Access Compliance Report Public Rights-of-Way (Pedestrian Signals)

Main Street: **CHIQUITA_CANYON_DR** Cross Street: **AIROSO_ST** Location: **NW**

ADA ID: **SGRK211130125658** Signal Type: **One Push Button-Non APS** Overall Compliance: **No** Severity Scores: **BTN 1: 10 BTN 2: N/A No BTN: N/A**

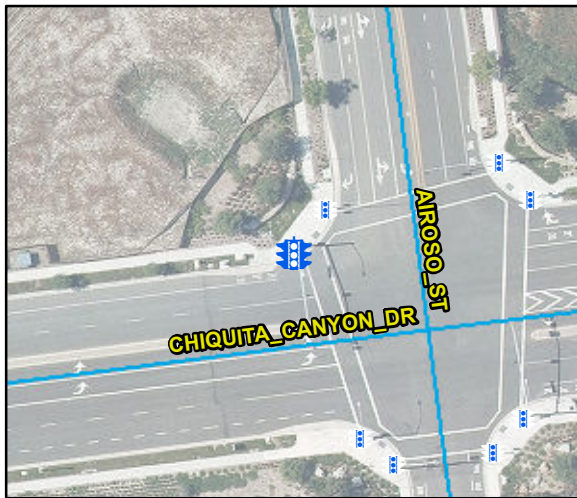
N/A Is Button 1 APS or Non-APS?	NonAPS	N/A Is Button 2 APS or Non-APS?	N/A
N/A B 1 VibroTact Arrow?	N/A	N/A B 2 VibroTact Arrow?	N/A
N/A B 1 VibroTact Parallel to Xing?	N/A	N/A B 2 VibroTact Parallel to Xing?	N/A
N/A B 1 VibroTact Contrast	N/A	N/A B 2 VibroTact Contrast	N/A
No B 1 Pilot Light?	No	N/A B 2 Pilot Light?	N/A
N/A B 1 Pilot Light Illumination?	N/A	N/A B 2 Pilot Light Illumination?	N/A
N/A B 1 Walk Indicator Type	N/A	N/A B 2 Walk Indicator Type	N/A
N/A B 1 Walk Indicator Audible?	N/A	N/A B 2 Walk Indicator Audible?	N/A
N/A B 1 Locator Tone?	N/A	N/A B 2 Locator Tone?	N/A
N/A B 1 Tone Audible Range?	N/A	N/A B 2 Tone Audible Range?	N/A
B 1 Addl APS Features?	No	B 2 Addl APS Features?	N/A
B 1 Addl APS Features Notes	N/A	B 2 Addl APS Features Notes	N/A

Possible Solutions: Replace Signal Push Button With APS Button.
